Summary Reviews of Select Aspects of the USEPA Upper Hudson River Models

**Presented to the USEPA Baseline Modeling Report Peer Review Members
March 27, 2000**

**Quantitative Environmental Analysis, LLC
Montvale, NJ 07645**

Figure 1. Numerical simulation of erosion in EPA sediment model.

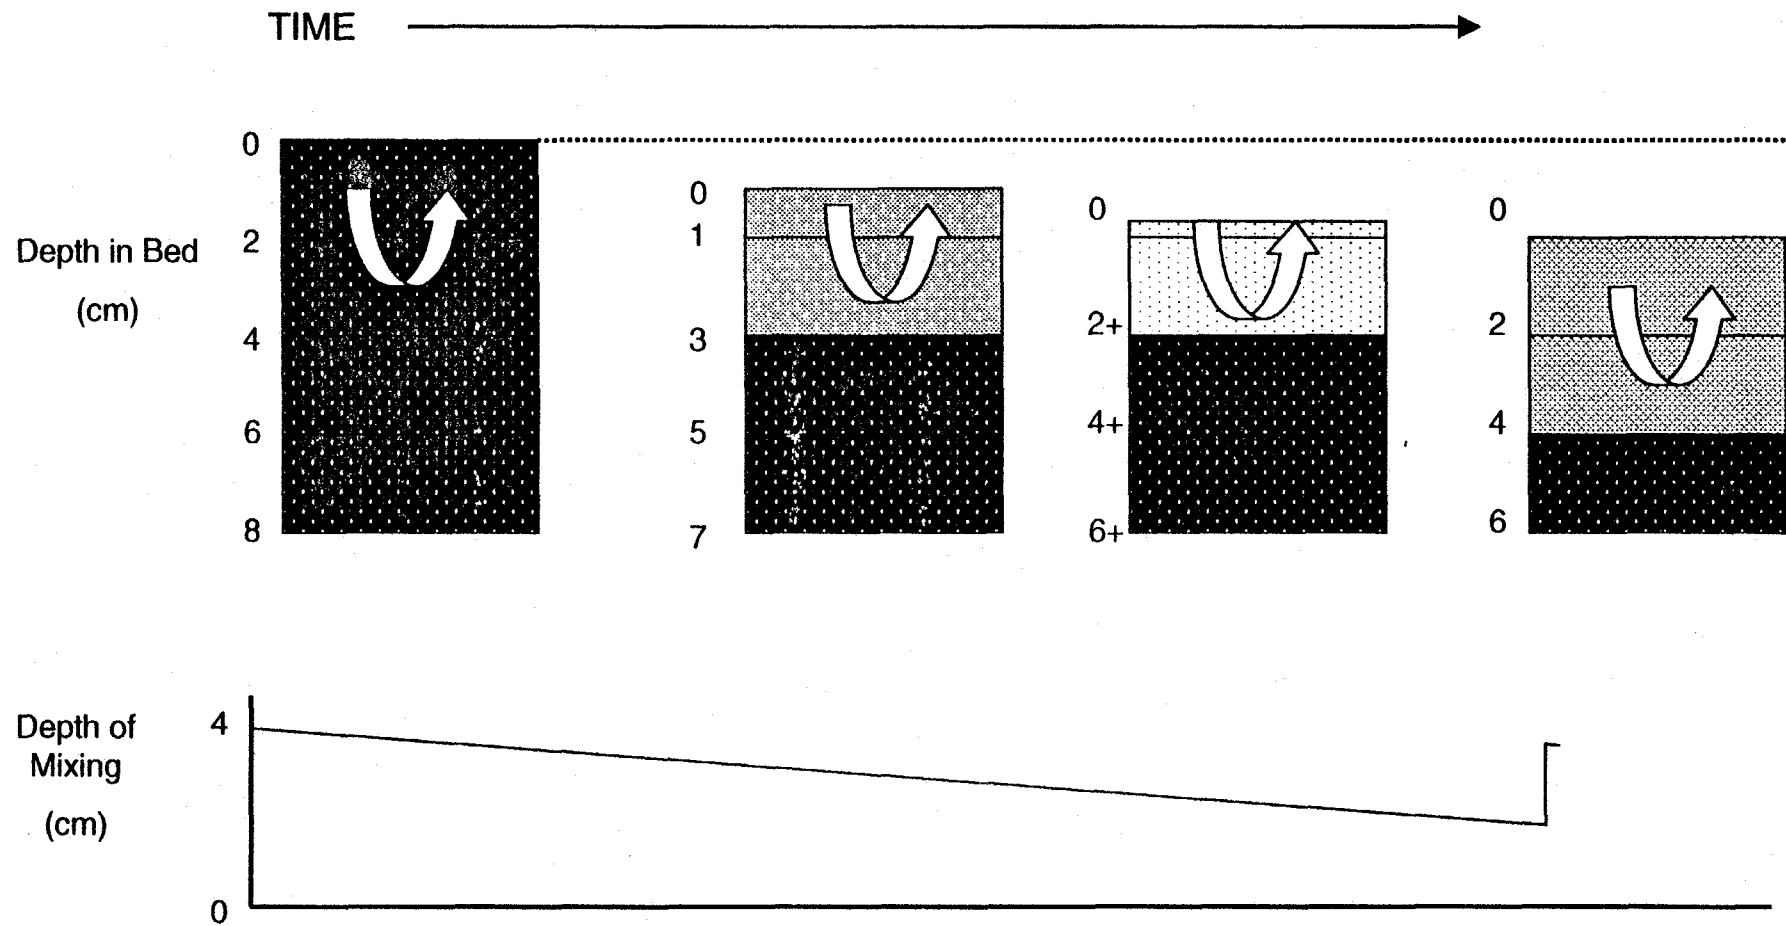
The model employs a 4 cm mixing depth. However, in areas of erosion or deposition, the model inadvertently changes the depth of the surface mixed layer over time (i.e., the depth subject to significant bioturbation) as a consequence of the sediment segmentation scheme and the numerical procedure. Where net erosion is calculated the depth of the topmost segment declines until it reaches some defined minimum value. At that time what remains of the top segment is incorporated in the segment below it and the sediment segments are renumbered by the model (Figure 1). Because particle mixing is calculated for a specified number of segments (e.g., the top two segments in the non-cohesive sediments of the Stillwater reach), the depth of sediment subject to mixing changes. In the case of the non-cohesive area of the Stillwater reach that is calculated to undergo net erosion, the mixed layer declines from 4 cm to almost 2 cm, instantly increases to 4 cm and then begins to decline again. The sudden incorporation of a sediment segment that was previously below the mixing layer and not subject to PCB loss mechanisms results in the calculation of a sharp increase in PCB concentration within the mixed layer (Figure 8-

4c of the RBMR). The reason the increase occurs after 40-50 years is that the net erosion rate is approximately 0.04 cm/year, so it takes about 50 years until that next lower 2 cm thick segment is redefined as part of the "top two segments".

The numerical artifact of declining and then instantaneously increasing the depth of the surface mixed layer is exacerbated by the manner in which the model results are presented. The predicted concentrations in Figures 8-4, (a-e) **do not** represent the top 0-4 cm of sediment as stated in Section 8.3. Instead, they represent an average of the top two sediment segments. Because the depth of the topmost layer changes, the depth of sediment represented in the figures changes also. The presented results in an area of net erosion track a progressively thinner layer of surface sediment (i.e., from 4 to 2 cm) and then instantly a thicker layer (i.e., 4 cm) that again becomes progressively thinner.

Figure 2. Illustration of error in EPA sediment model.

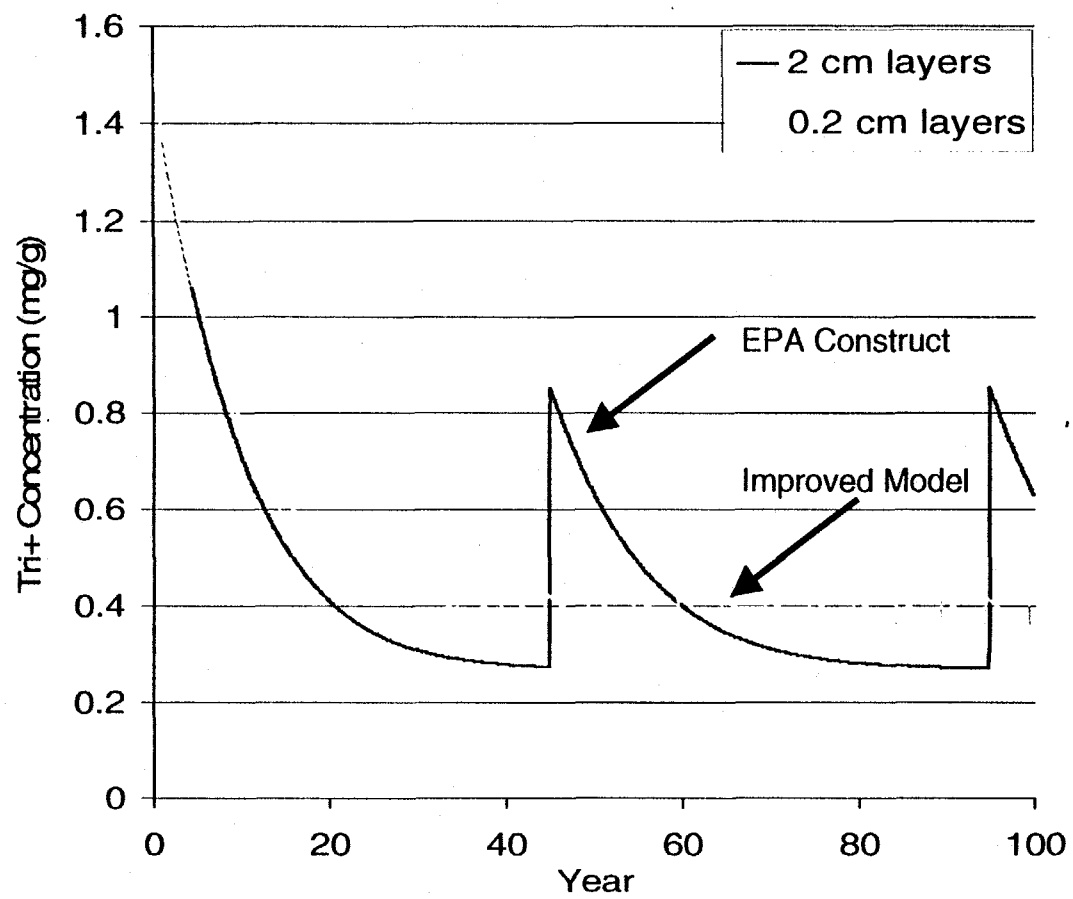
Evidence that the predicted increases are due to the model's numerical procedures rather than a real phenomenon can be obtained by examining how the predicted increases change as the resolution of the numerical grid is changed. QEA ran it's bed model using EPA's parameters for particle mass transfer, net erosion, and molecular mass transfer as well as a mixing depth of 4 cm as was used in the Stillwater Reach. The model was run with a segment thickness of 2 cm as well as 0.2 cm to demonstrate that the apparent increase is easily reproducible and a function of layer thickness. We were able to reproduce the sudden increase when using 2 cm layers (Figure 2). As the sediment model

segmentation was refined, the sharp increases due to this numerical artifact began to disappear. As shown in Figure 2, use of segments 0.2 cm thick results in near complete elimination of the increases.

Figure 1. Comparison of USGS and GE solids load sampling methods.

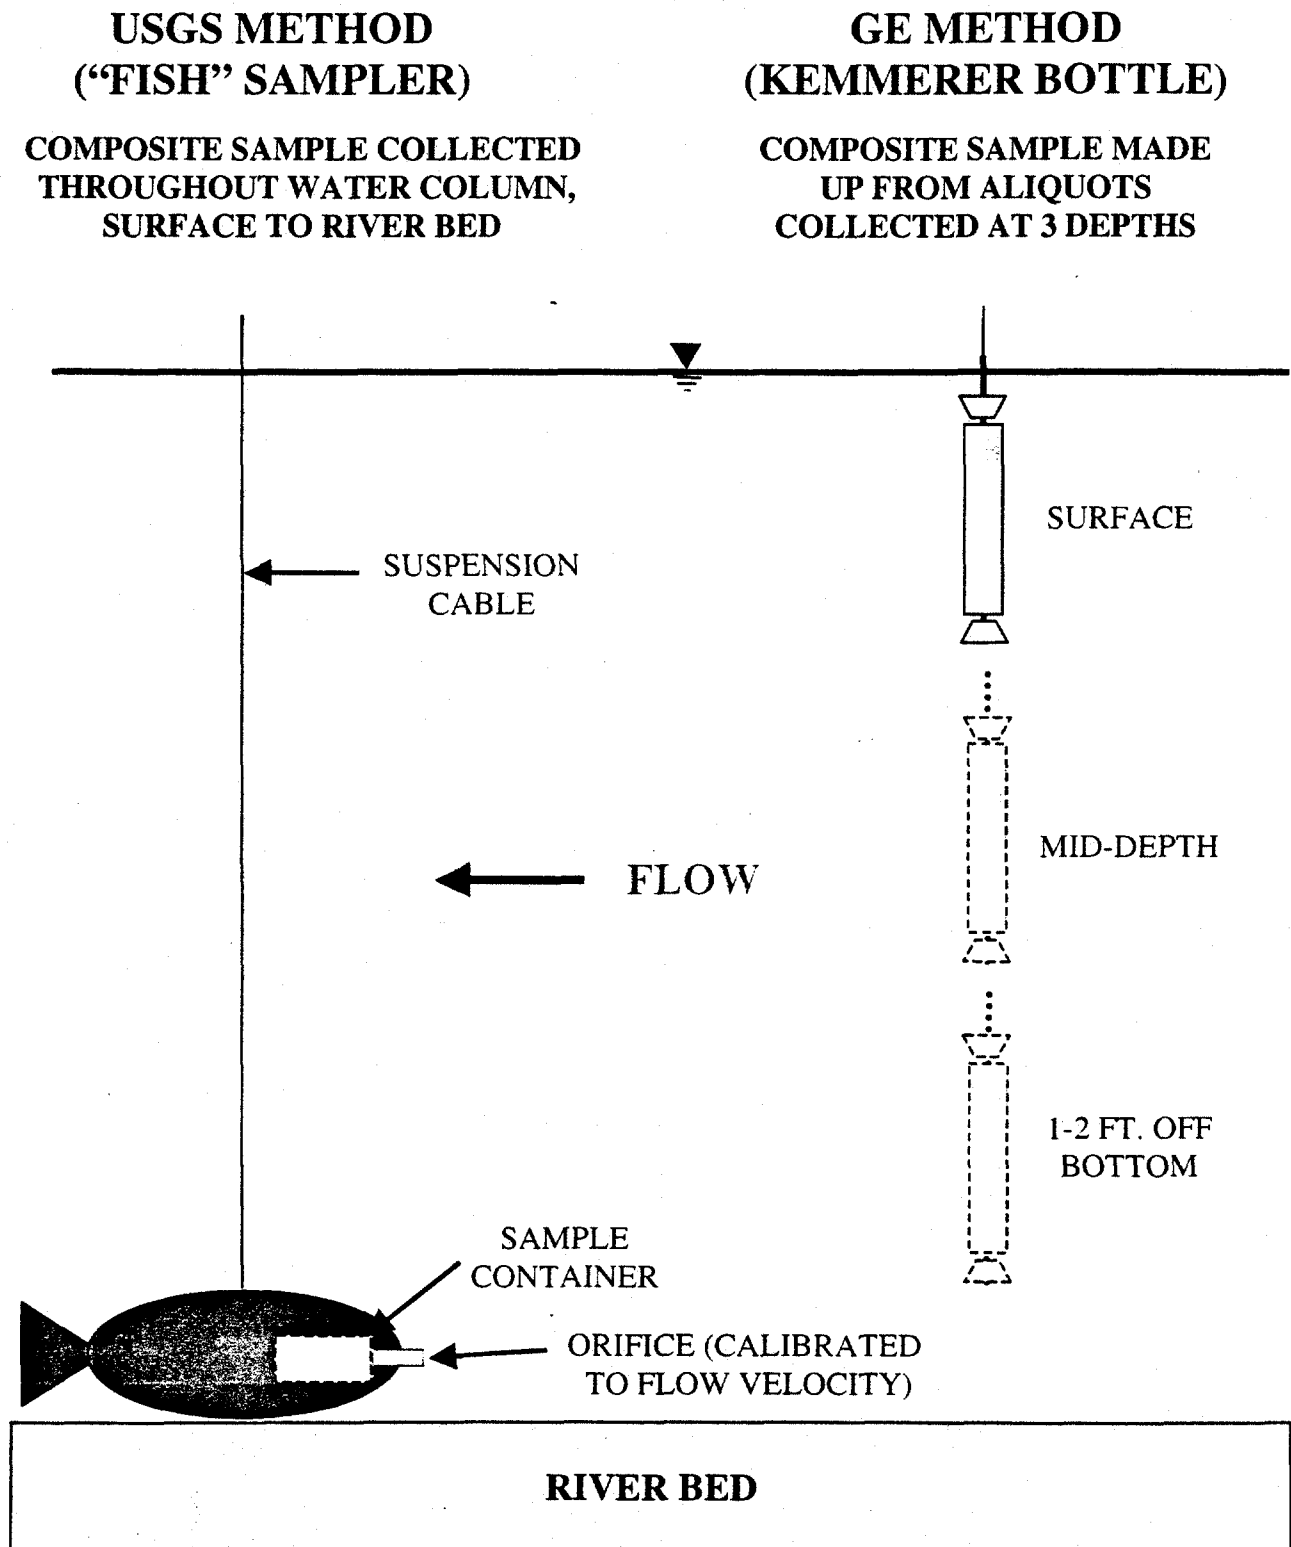
Both USEPA and GE have estimated Fort Edward solids loading during periods when data are unavailable using rating curves developed from total suspended solids (TSS) concentration and flow rate data collected at the Rogers Island sampling station located at the upstream limit of the TIP (QEA 1999, USEPA 2000). Flow rates are measured by the U.S. Geological Survey (USGS) at the Fort Edward gauging station and are typically reported as daily-average values. The two primary TSS data sources are: 1) USGS, which has collected samples from 1977 to the present and 2) GE, which has collected samples since 1990. There are significant differences in the TSS sampling equipment and procedures used by USGS and GE (Figure 1), and these differences affect the interpretation of TSS concentration data.

There are two reasons that support the use of the USGS data to estimate solids loadings. First, the USGS methodology is specifically designed to measure sediment loads, whereas GE's methodology is not. GE samples are taken at three locations in the water column: 0.2, 0.5 and 0.8 times the depth (e.g., in 2 m of water, the bottom GE sample

would be 40 cm above the sediment bed). The USGS method, in contrast, utilizes a sampler that samples continuously throughout the water column, from the surface to within 6 cm of the sediment bed. Thus, the GE method does not produce a vertically-averaged TSS concentration that adequately samples near-bed sediments, where a major fraction of the suspended sand load is located. In addition, the USGS sampler is a flow-through device that is specifically designed for sampling suspended sediment. A Kemmerer sampler is used by GE to collect TSS samples. The design of this device is such that suspended sands, with relatively high settling speeds, may not be adequately sampled. Second, the USGS methodology has remained constant throughout the relevant period (i.e., 1977 to the present), whereas GE's different methodology was introduced in 1990. It is far preferable to use a consistent data set than to rely on data from two different methodologies. Thus, it is appropriate to rely primarily on the USGS data set to establish solids loading over time at Fort Edward.

Figure 2. Estimated solids loading at Ft. Edward for post-1990 (1991-1998) period using various rating curves. Error bars represent the 95 % confidence interval.

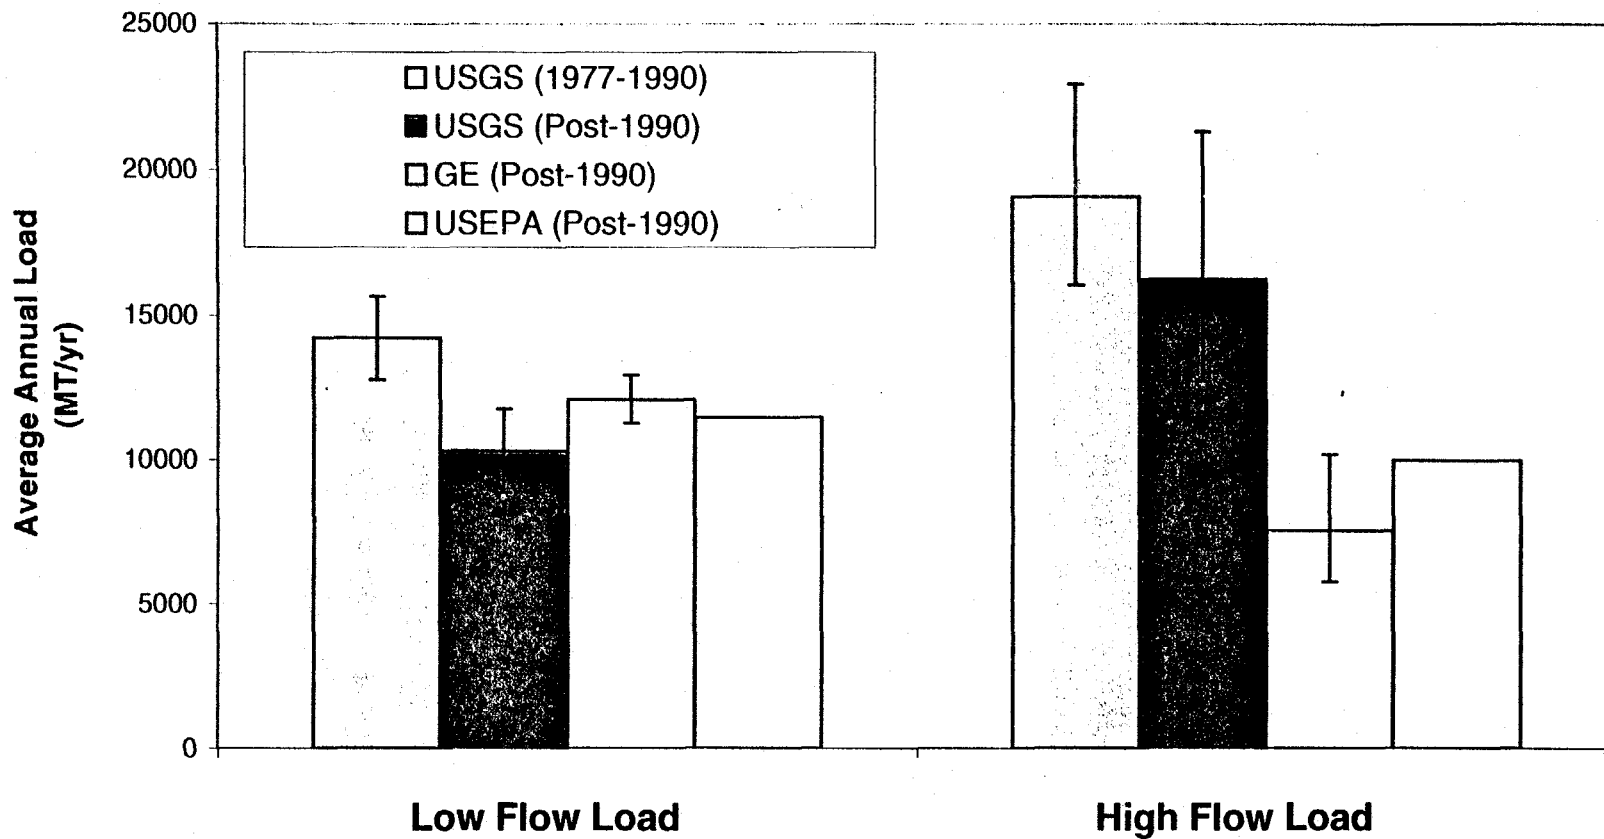
This analysis indicates that USEPA's conclusion concerning temporal changes in solids loading at Fort Edward is incorrect. Inclusion of the GE data in the development of the post-1990 rating curve causes an underestimation of Fort Edward solids loading. For example, the USEPA rating curve for the post-1990 period yielded an average annual solids load of 21,500 MT/yr for the 1991-1998 period, which is 20% lower than the load estimated using the post-1990 USGS rating curve (Figure 2). Use of solids loading inputs to HUDTOX that are too low during post-1990 and projection periods will reduce predicted sedimentation rates, affect the calculated rate of natural recovery and may incorrectly skew the efficacy of various remedial actions. Therefore, the use of an artificially low solids load at Fort Edward introduces an error into USEPA's model.

Figure 3. Fort Edward solids rating curves using three different data sets.

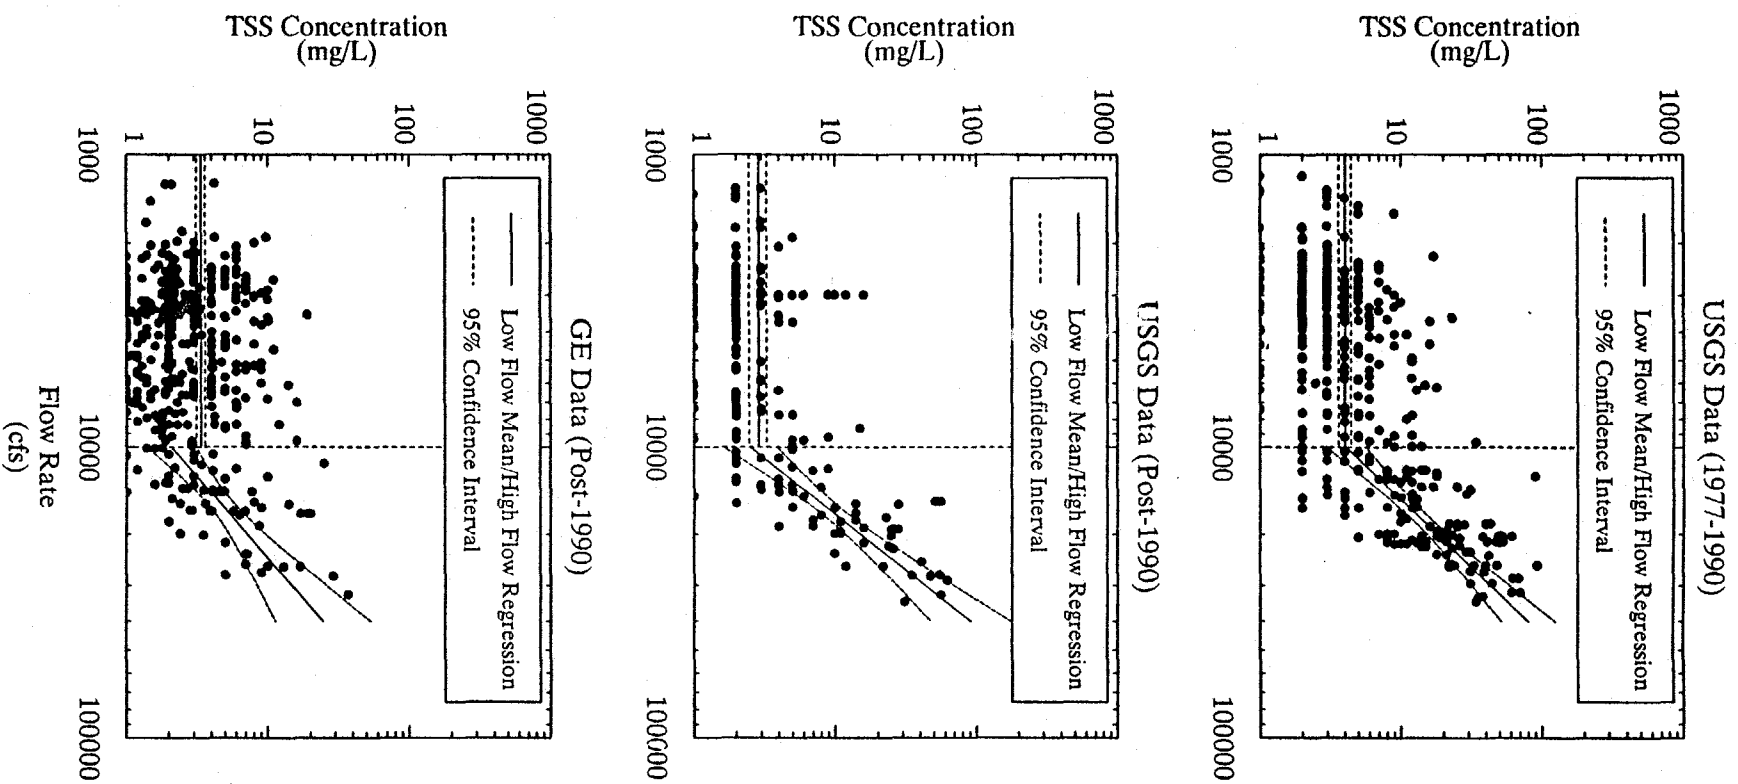
It appears that USEPA's hypothesized reduction in solids loading after 1990 is due to the Agency's reliance on the GE data, as illustrated by comparing the USGS post-1990 rating curve with the GE post-1990 rating curve. Comparing the two data sets in this manner is crucial because: 1) all of the data are used, not just a limited number of paired measurements and 2) differences in solids loading estimates can be quantified. Large differences between the resulting rating curves, particularly in the high-flow regime, are evident in Figure 3. These rating curves were used to calculate Fort Edward solids loading for an eight-year period, from January 1, 1991 to December 31, 1998 (Figure 2). The rating curve developed from the GE data produced a total solids load for this period that was 24% lower than the USGS rating curve overall, with a much larger difference during high-flow periods (54% lower) than during low-flow periods (17% higher). The apparent low-bias of the GE TSS concentration data during high-flow conditions probably results from the configuration of the sampling device and the sampling procedure, as described previously (Figure 1). Thus, the GE TSS concentration data should not be used for calculating total suspended solids loading at Fort Edward.
